International
Aero Engines

V2500 Propulsion System — Nacelle

SERVICE BULLETIN

**NACELLE - POWER PLANT - FORWARD MOUNT INCREASED CLEARANCE MONOBALL STOP
AND INCREASED STRENGTH BOLT UPGRADE**

Replacement of Engine Mount Bolts and Monoball Stop
Figure 1

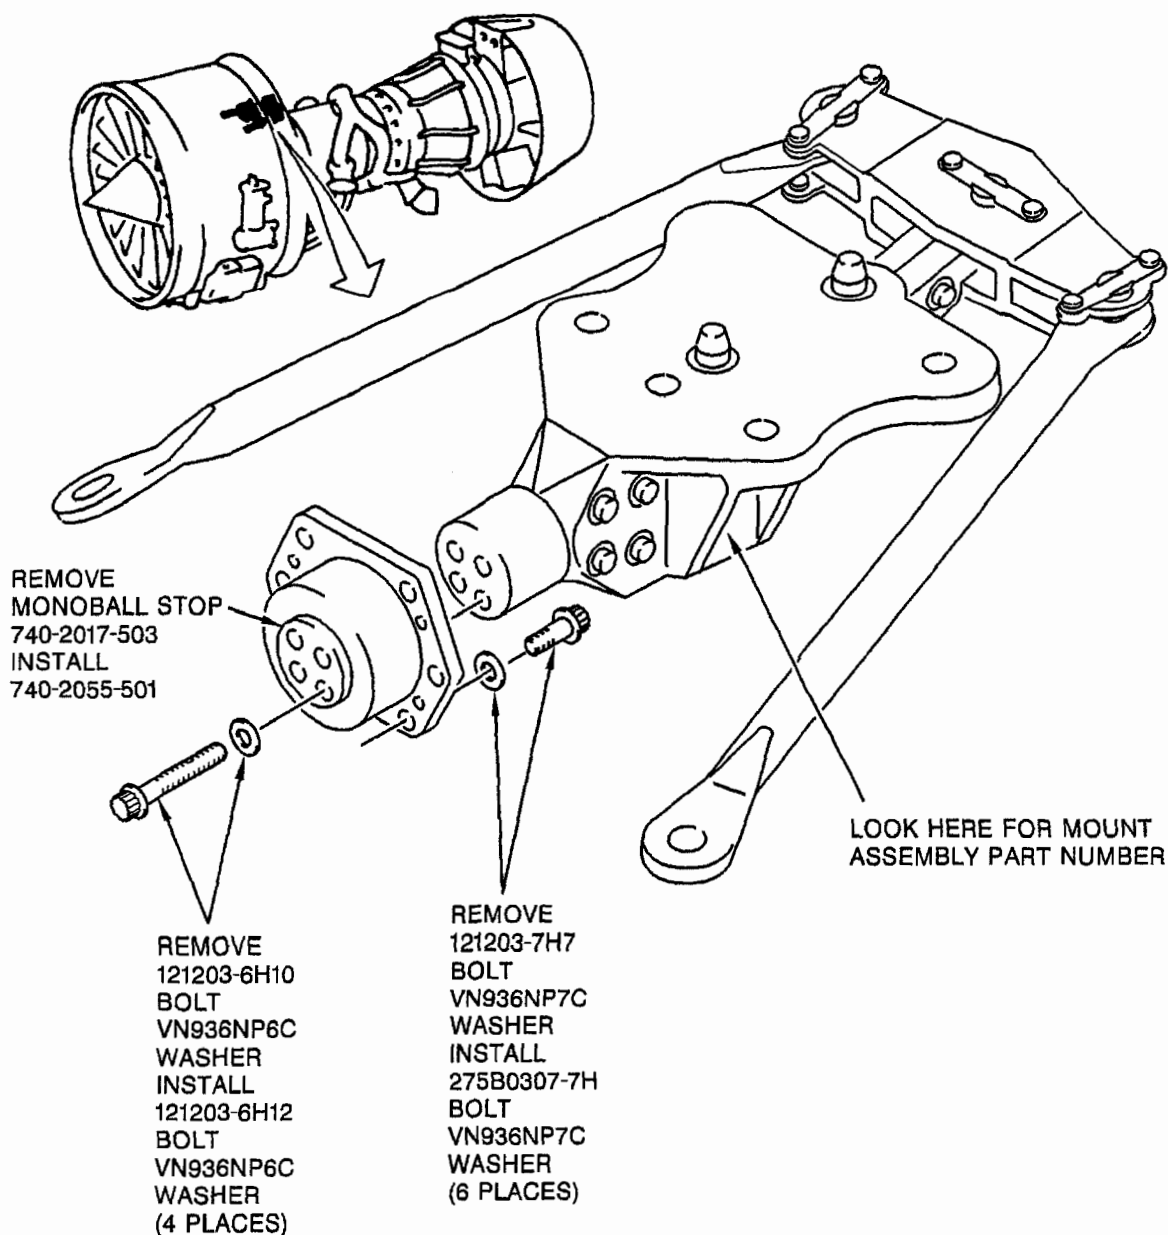
- (1) Remove the forward engine mount from the engine. Refer to the A320/V2500-A1/A320/A321/V2500-A5 Engine Manual, Task 71-00-32-350-001. Discard the six 121203-7H7 bolts. Keep the washers.
- (2) Remove the lockwire, four bolts 121203-6H10, four washers VN936NP6C and the monoball stop. Discard the bolts and monoball stop. Keep the washers. Refer to Figure 1.

- (4) Install the monoball stop 740-2055-501 with four bolts 121203-6H12 and washers VN936NP6C. Lubricate the bolts with CoMat 10-077 engine oil. Torque the bolts to 520-630 lb-in. (58.7-71.2 N.m).
- (5) Safety the bolts with lockwire (CoMat 02-147).
- (6) Re-identify the forward engine mount assembly as instructed in Part 3 of this service bulletin.
- (7) A record of accomplishment is required. Note in the aircraft log that Service Bulletin V2500-NAC-71-0135, Part 1 has been incorporated.

Engine Mount Bolts Intallation and Re-Torque
Figure 2

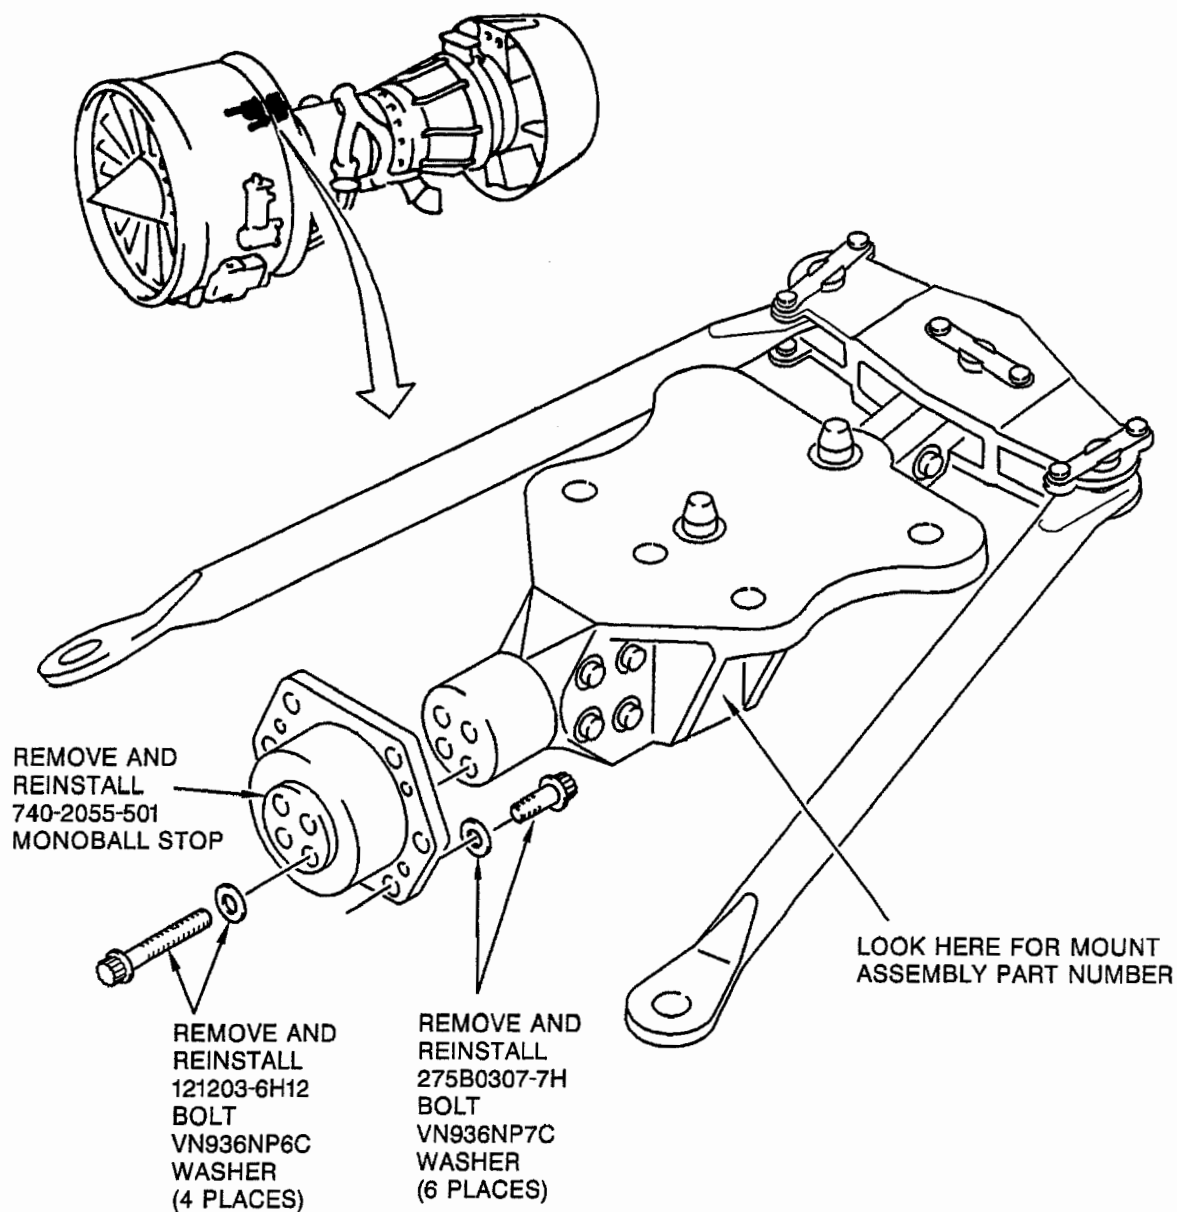
- (1) Remove the forward engine mount from the engine. Refer to the A320/V2500-A1/A320/A321/V2500-A5 Engine Manual, Task 71-00-32-350-001. Keep the bolts and washers.
- (2) Remove the lockwire, four bolts 121203-6H12, four washers VN936NP6C and the monoball stop. Keep the bolts, the washers and the monoball stop. Refer to Figure 2.

- (4) Install the monoball stop 740-2055-501 with the bolts 121203-6H12 and washers VN936NP6C. Lubricate the bolts with CoMat 10-077 engine oil. Torque the bolts to 520-630 lb-in. (58.7-71.2 N.m).
- (5) Safety the bolts with lockwire (CoMat 02-147).
- (6) Re-identify the forward engine mount assembly as instructed in Part 3 of this service bulletin.
- (7) A record of accomplishment is required. Note in the aircraft log that Service Bulletin V2500-NAC-71-0135, Part 2 has been incorporated.

Monoball Stop Dimension Check
Figure 3

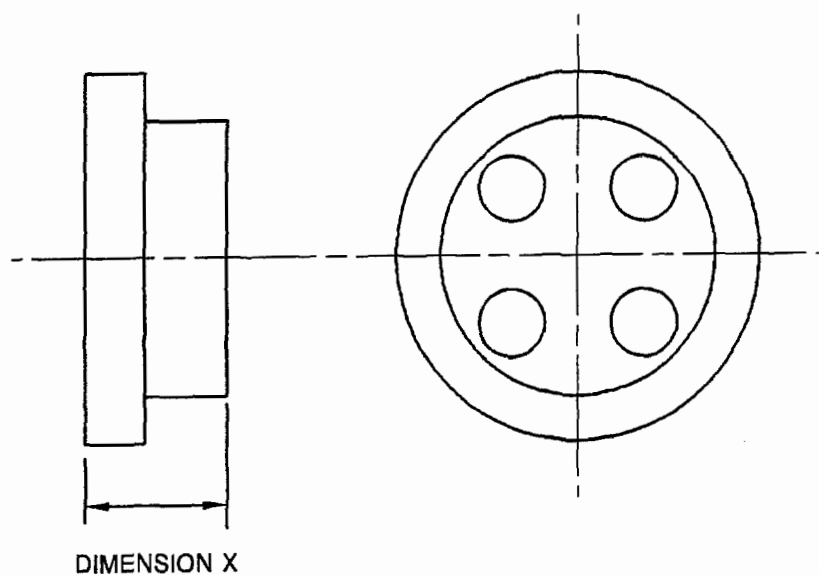
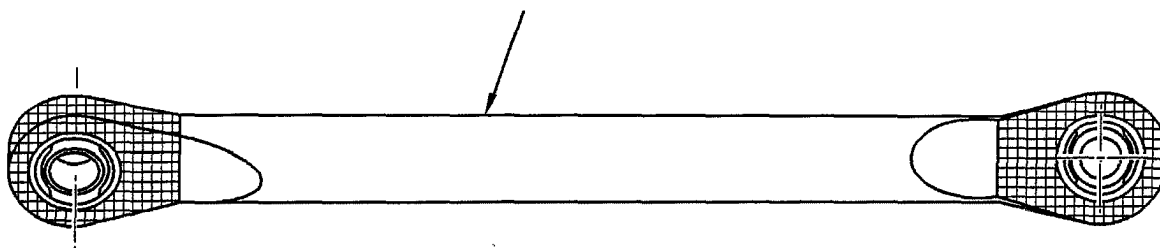
(c) If you cannot find a monoball stop part number, measure the monoball stop as shown in Figure 3.

- 1 If the monoball stop dimension X measurement is 0.836 inch (21.23 mm), re-install the monoball stop as instructed in Part 2 of this service bulletin and re-identify the mount as instructed in Part 3.
- 2 If the monoball stop dimension X measurement is 0.730 inch (18.54 mm), replace with the 740-2055-501 monoball stop as instructed in Part 1 of this service bulletin and re-identify the mount as instructed in Part 3.
